134-150 S Blair

Certificate of Appropriateness & Variance

May 20, 2024

## MGO 41.19 Variances

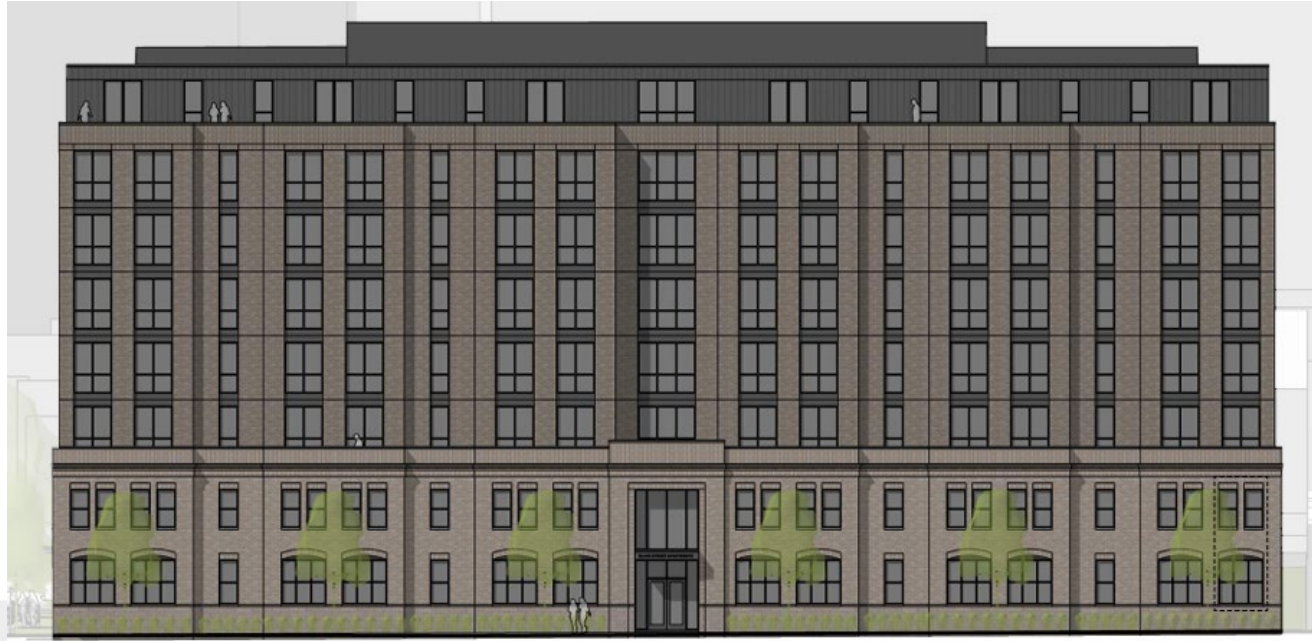
(6) Alternative Design Variance. The Landmarks Commission may grant a variance allowing, in a new or altered structure, elements that are otherwise prohibited under Sec. 41.18 if all of the following apply:

- (a) The elements will enhance the quality of the design.
- (b) **The design complies with all other applicable standards under Sec. 41.18.**
- (c) The design does not allow material deviations from historic district standards and guidelines that would undermine the character or purpose of the historic district.
- (d) The design will have a beneficial effect on the historic character of the area within two hundred (200) feet of the subject property.

## MGO 41.27 Standards for New Structures

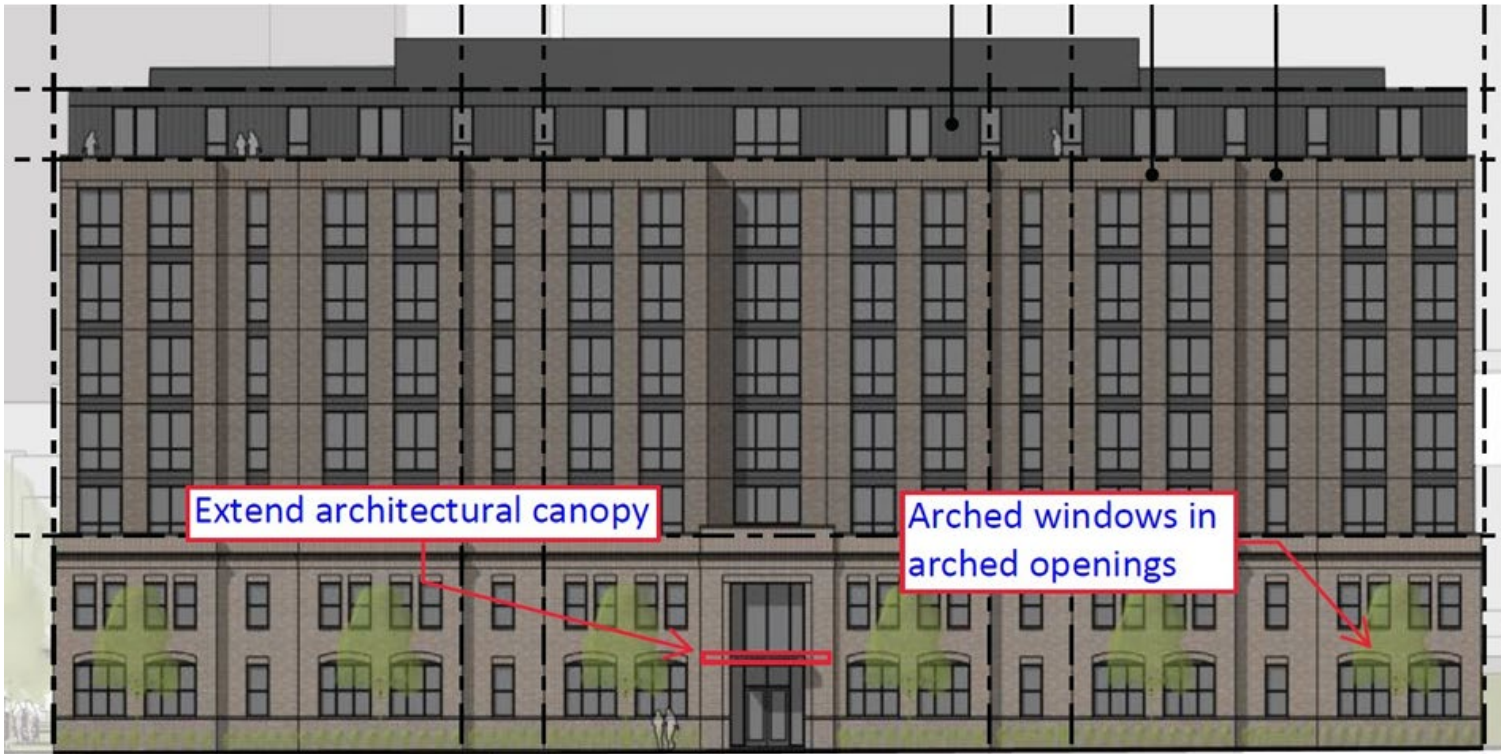
5. Architectural Expression. When determining visual compatibility for architectural expression, the Landmarks Commission shall consider factors such as the building's modulation, articulation, building planes, proportion of building elements, and rhythm of solids to voids created by openings in the façade.

### (7) Building Systems [need info on mechanicals & utilities]

1. Redesign the front entry to include an architectural canopy that spans the central bay of the building
2. Final door, window, railing, and fencing specifications to be administratively approved by staff. Arched windows need to be in the arched openings on the front façade
3. Information on mechanicals and utility locations on the building to be administratively approved by staff
